Stage of inspection: Final.

Builder:

Schedule of Defects:

<u>Defects, observations and other related comments from the Final Inspection on the 19/04/2021:</u>

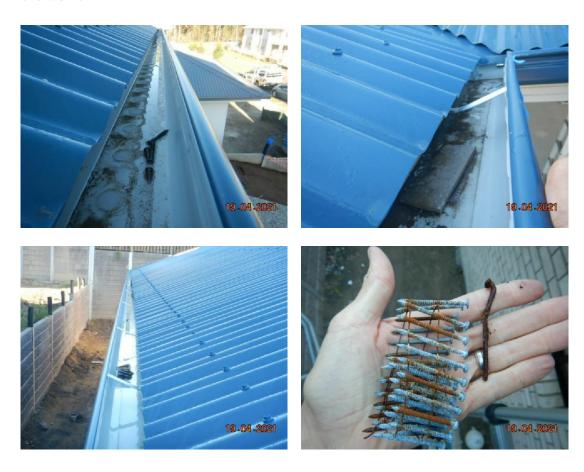
The BlueScope Colorbond roofing products to the dwelling have been damaged during construction.

BlueScope Technical Bulletin-38: - BlueScope <u>do not</u> support the use of touch-up paints on 'Colorbond' steel, and that their use will invalidate the BlueScope Warranty.

Damaged areas greater than 2mm in width will need to be replaced.

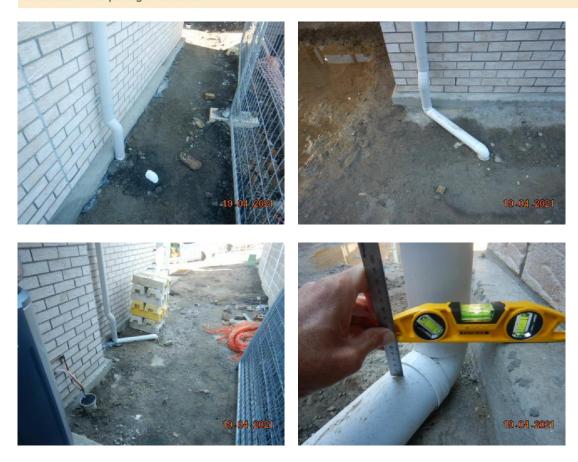
NCC, part 3.1.3.5: - It was noted the storm water system is presenting with less than the required coverage to the areas as documented in the photographs below.

All areas must meet the minimum standards set out in the NCC.

Figure 3.1.3.2 Site surface drainage

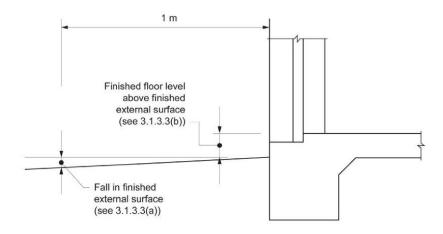
NCC, 2019; 3.1.3.3: - The external finished surface surrounding the slab must be drained and graded to give a slope of not less than 50mm over the first 1 metre. (25mm in areas of *low rainfall intensity areas*)

Surface water drainage on this site has not met the performance requirements of the National Construction Code.

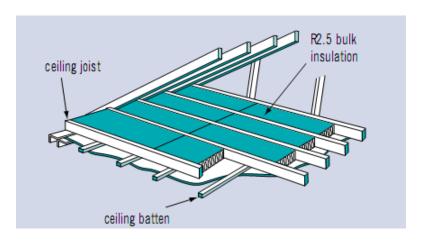
The insulation in the ceiling has the following defects.

- Batts have been installed over pipes, wires, and framing. The 90 mm plus gap between the top of the plaster and the bottom of the batts is making all installed batts that have this gap completely ineffectual. The R rating on the dwelling has been greatly reduced and the overall performance of the roof installing does not meet the requirements of the energy report on the dwelling. The whole roof will need to be reworked so that all batts are installed hard to the plaster with no gaps or holes to the installation.
- Other trades appear to have removed batts from their work areas with little regard for the information inserted below. Note that batts must be installed up to the 50 mm area around protected down lights.

These areas require insulation as per the energy rating requirements of the dwelling.

The insulation needs to be reworked to be installed in a manner that complies with AS 3999 with all areas covered and the batts flush to the top of the plaster.

The inserted diagram demonstrates the minimums that must be achieved.

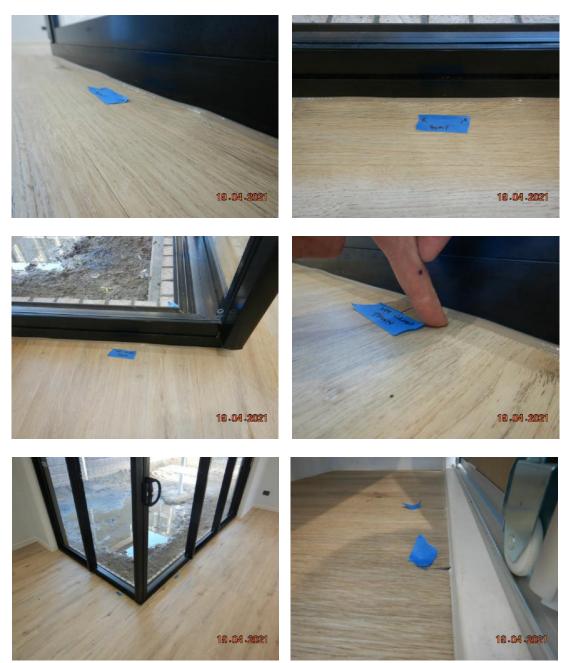
Silicone not tooled off

Screw missing

Wedge sticking out under screens

Cutlry tray short

Door guide sticking out
